DR-25-04 Incompleteness Response

SUBJECT: Class II Design Review at 2410, 2422, and 2444 Tannler Drive.

The city accepted this application for review on September 24, 2025. The Planning and Engineering Departments have reviewed your application and found it **incomplete**. The following items must be addressed:

Clear vision area for corner lots and driveways 24 feet or more in width:

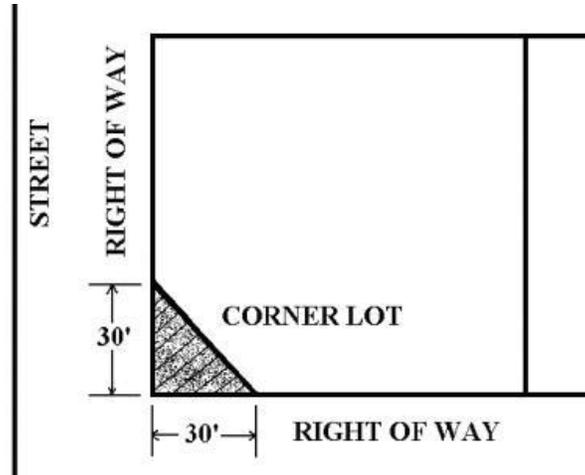
1. Demonstrate compliance with the clear vision standards, show on site plan (Chapter 42.020, 42.040)

Response: As proposed, the design includes clear vision triangles at the intersection of the driveways with Tannler Drive. The clear vision areas have been calculated consistent with the figure above as the proposed driveways are 24 feet in width. Please see sheets C200 for detailed locations and dimensions. As proposed, the development has been designed to comply with these requirements.
